## Remplacement DI24D par DC24D en mode régulation de pression

## Remplacement DI24DE par DC24DE en mode post de froid

## Remplacement DI24EE par DC24EE en mode post de froid

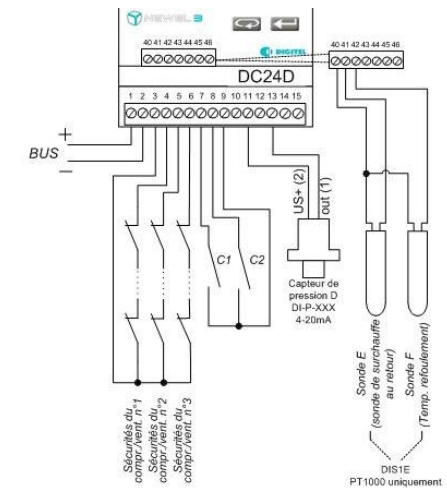
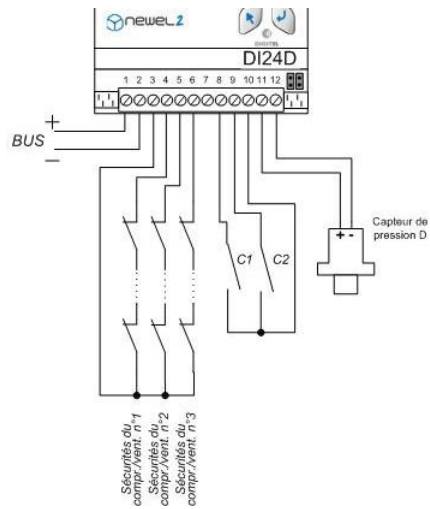
| DI24D |   | DC24D/DE |
| 1     | → | 1        |
| 2     | → | 2        |
| 3     | → | 3        |
| 4     | → | 4        |
| 5     | → | 5        |
| 6     | → | 6        |
| 8     | → | 7        |
| 9     | → | 8        |
| 10    | → | 9        |
| 11    | → | 11       |
| 12    | → | 13       |

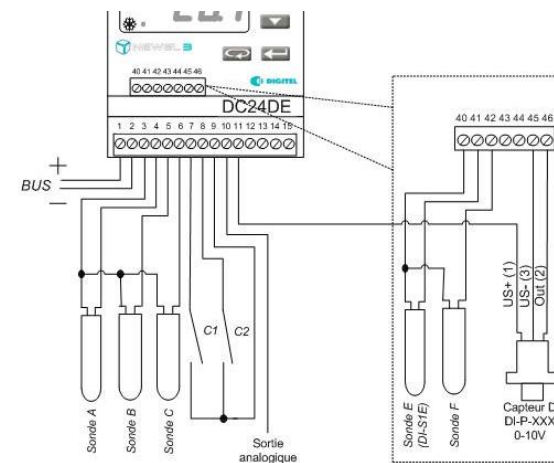
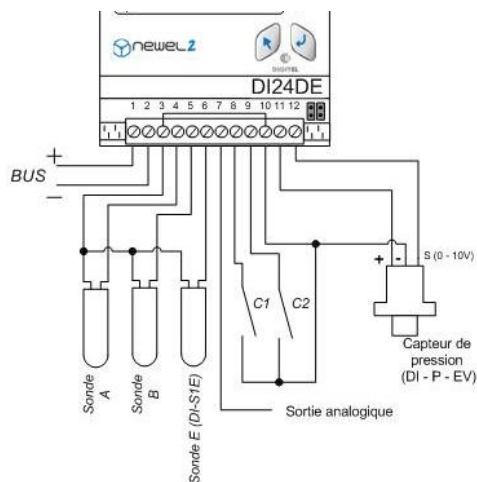
| DI24DE            |   | DC24DE |
| 1                 | → | 1      |
| 2                 | → | 2      |
| 3                 | → | 3      |
| 4                 | → | 4      |
| 5                 | → | 5      |
| 6                 | → | 41     |
| 7                 | → | 10     |
| 8                 | → | 7      |
| 9                 | → | 8      |
| 10 (C1 et C2)     | → | 9      |
| 10 (- du capteur) | → | 45     |
| 11                | → | 11     |
| 12                | → | 46     |

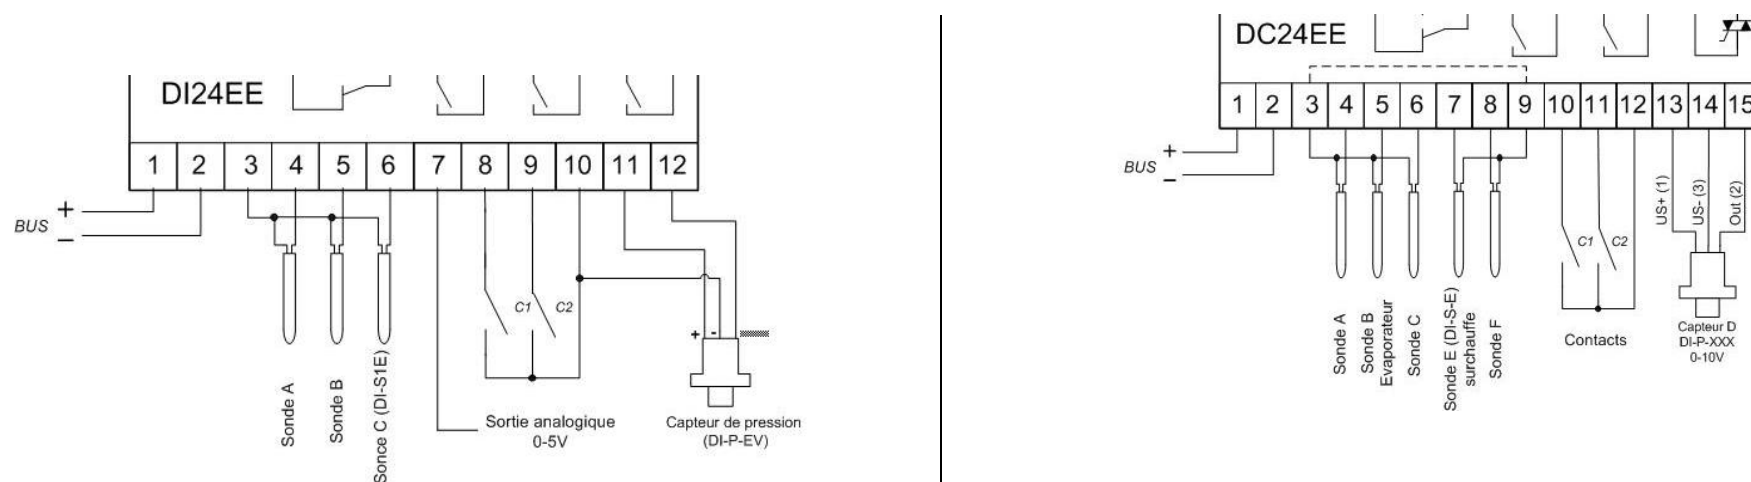
| DI24EE            |   | DC24EE        |
| 1                 | → | 1             |
| 2                 | → | 2             |
| 3                 | → | 3             |
| 4                 | → | 4             |
| 5                 | → | 5             |
| 6                 | → | 7             |
| 7                 | → | n'existe plus |
| 8                 | → | 10            |
| 9                 | → | 11            |
| 10 (C1 et C2)     | → | 12            |
| 10 (- du capteur) | → | 14            |
| 11                | → | 13            |
| 12                | → | 15            |
